**INVITATION TO BID 2024-01
CITY OF PARKER
INLAND FLOOD PROTECTION RETENTION POND AND WALKING PATH**

**ADDENDUM NO. 1
REQUESTS FOR INFORMATION**

Issued March 8, 2024

**MAINTENANCE OF TRAFFIC
SITE PLAN**

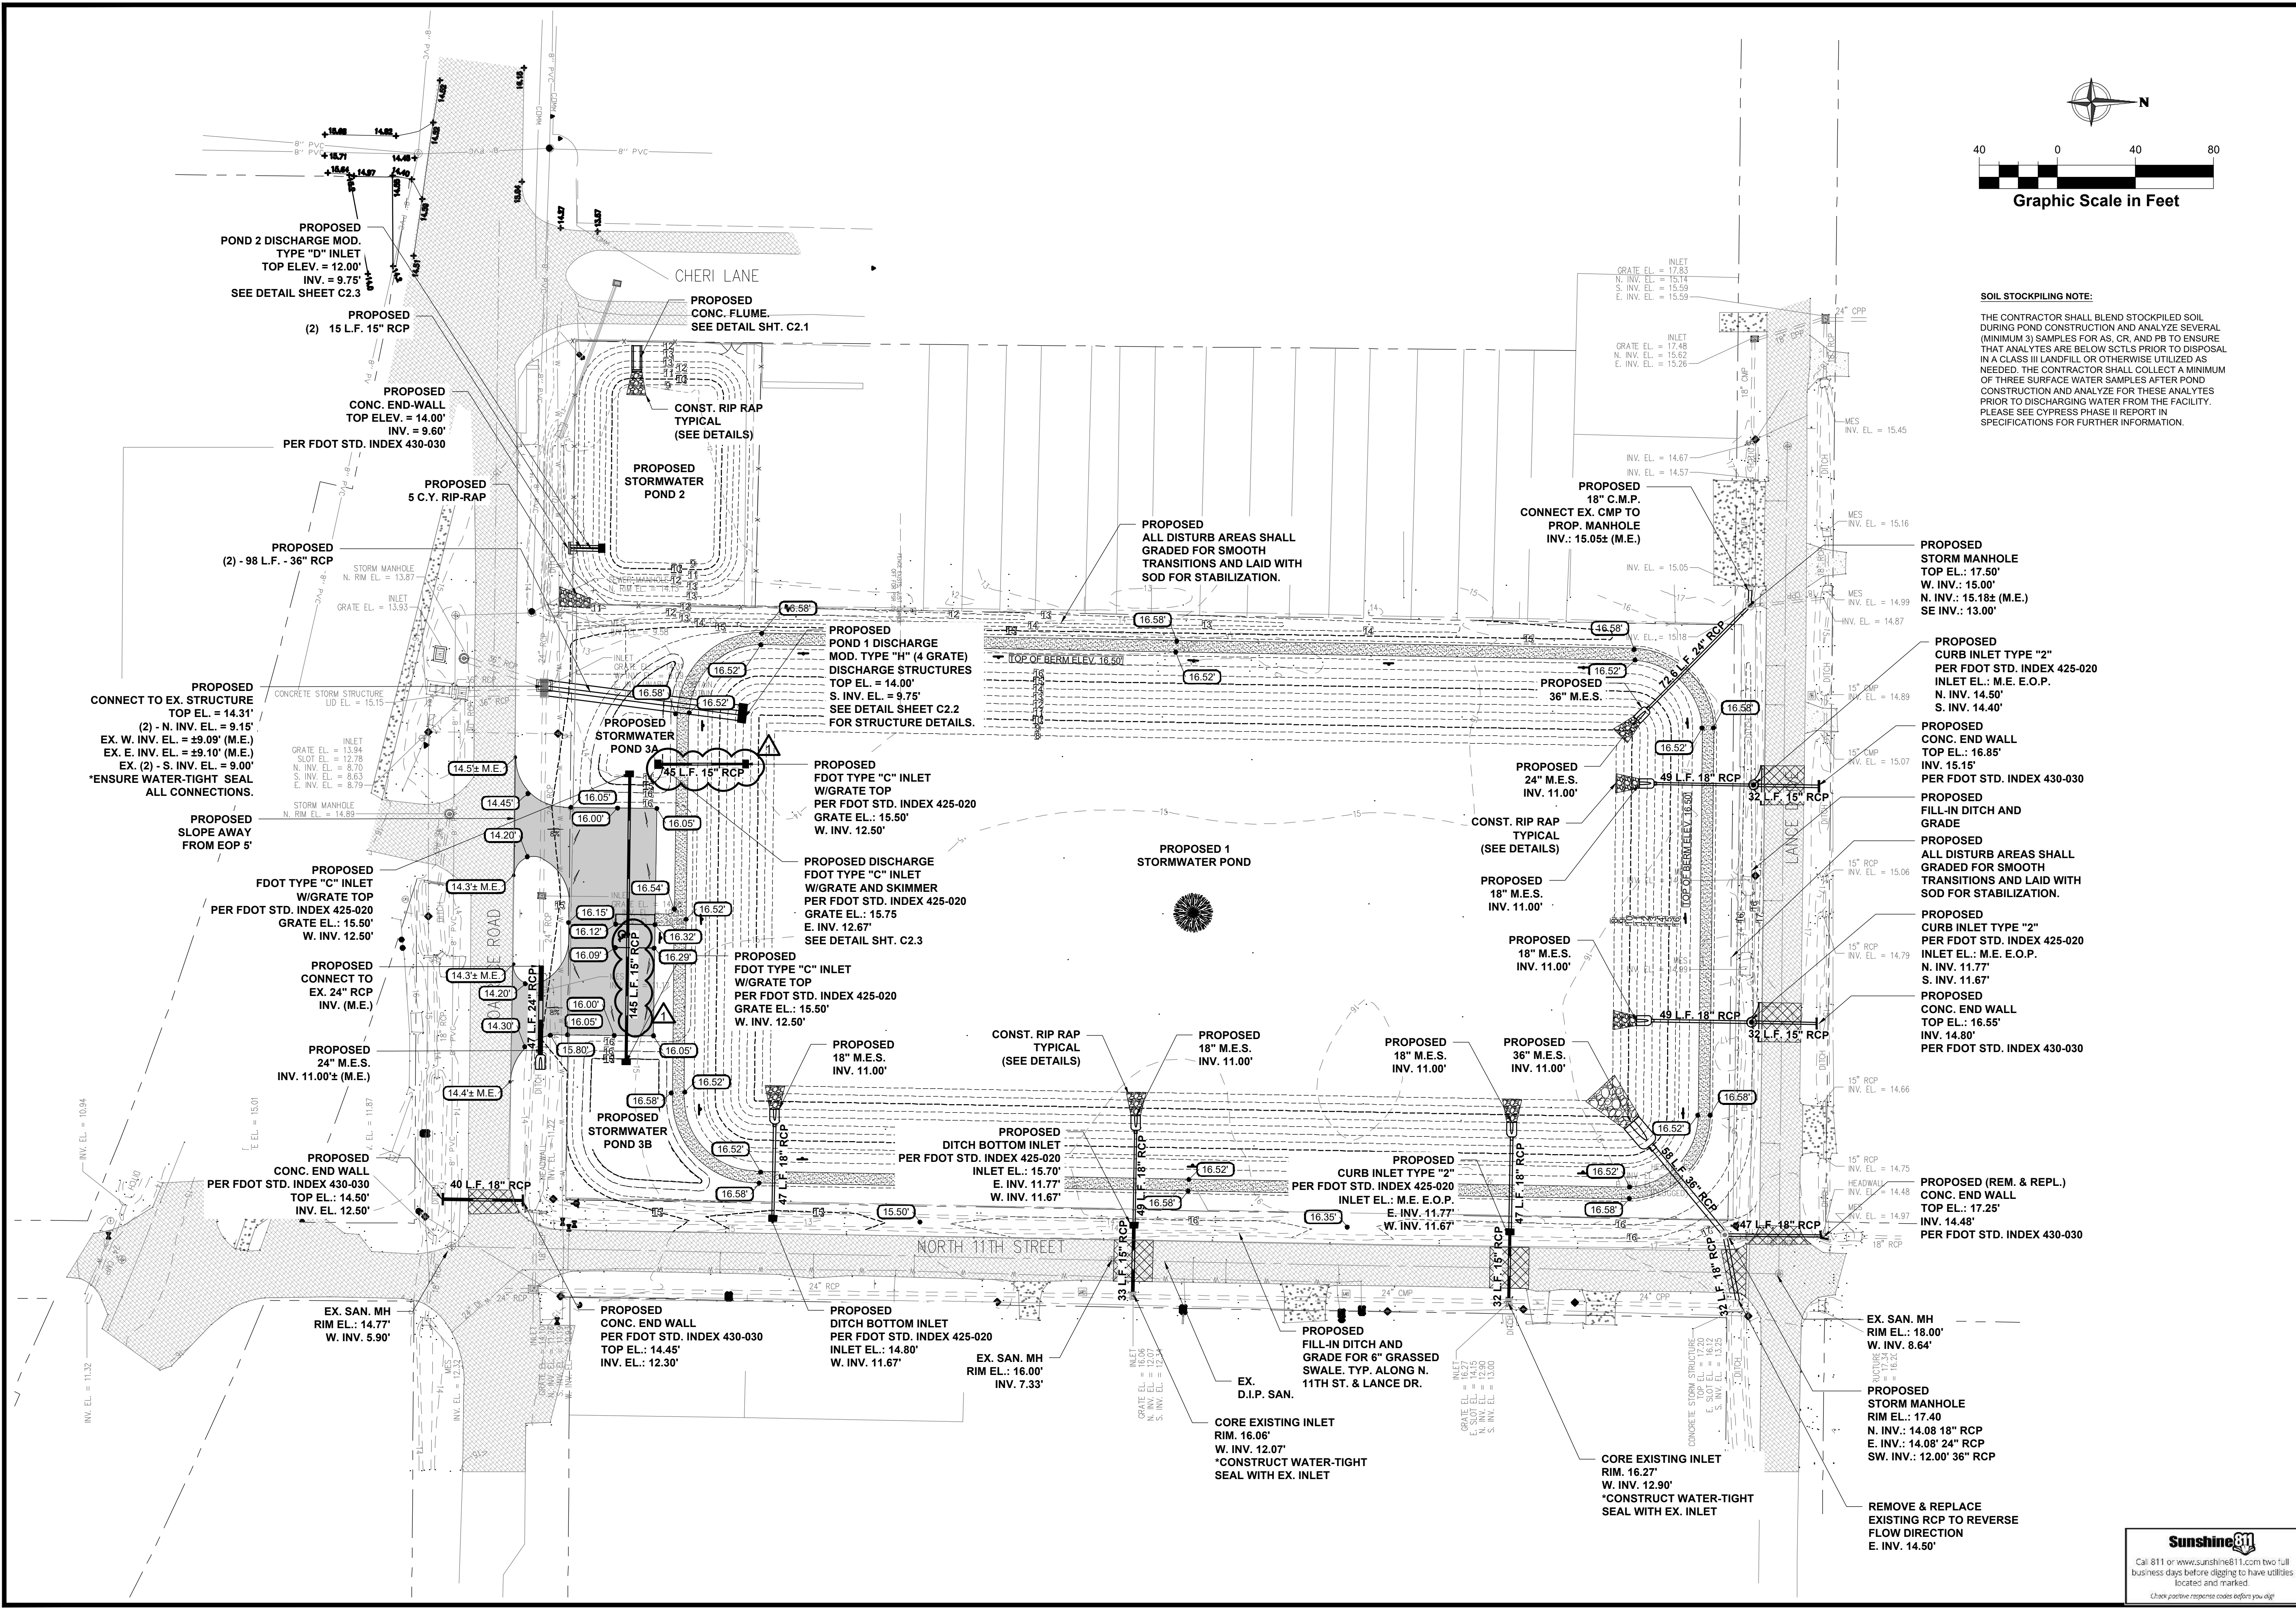
RAI No. 4. As you know there will be a lot of heavy equipment vehicle movement do to the excavation and we were concerned about the traffic schedule in the area in order not to affect neighborhood commute. Not sure if there is an established or preferred route already delineated for the trucks hauling excavated material from the site. Please confirm.

RAI No. 17. Will road closures be allowed for the install of pipe crossings since there are ways to divert traffic around the crossings?

All heavy equipment should enter and exit the site using the construction entrance, as shown, on Boatrace Road. Residential roads such as Lance Street and 11th Street North should be avoided as much as possible. An MOT sheet has been added to the plan set.

A MOT Plan has been included in the revised Civil Construction Plans for assistance in determining lane closures for cut and patch work along Lance Street, 11th Street North, and Boatrace Road.

If it is determined that a complete road closure is needed, then Contractor must coordinate with the City of Parker Public Works for approval prior to closure of that City roadway.

TRENCH DETAIL ASPHALT PAVEMENT SURFACE TYPE A-1 PIPE BEDDING

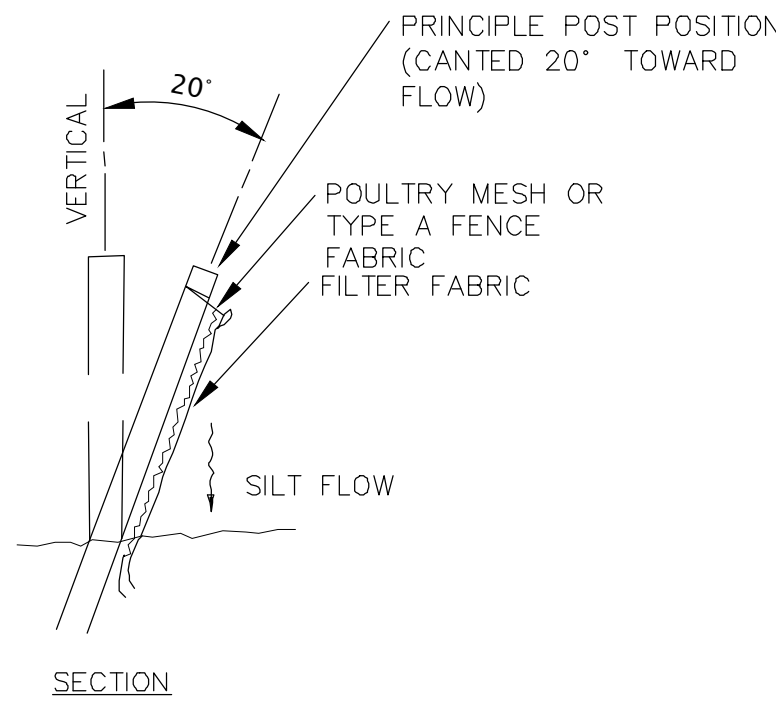
RAI No. 6. The trench detail on SHEET C2.0 reflects sheet piles; however, I do not believe sheets will be necessary for the construction of this storm drain. Please review.

City's Response to Request for Information Question No. 6

It is unlikely sheet piles will be necessary to construct this project. Note 6 under the Trench Detail Asphalt Pavement Surface Type A-1 Pipe Bedding Detail on SHEET C2.0 has been removed. Please refer to the revised Civil Construction Plan Set.
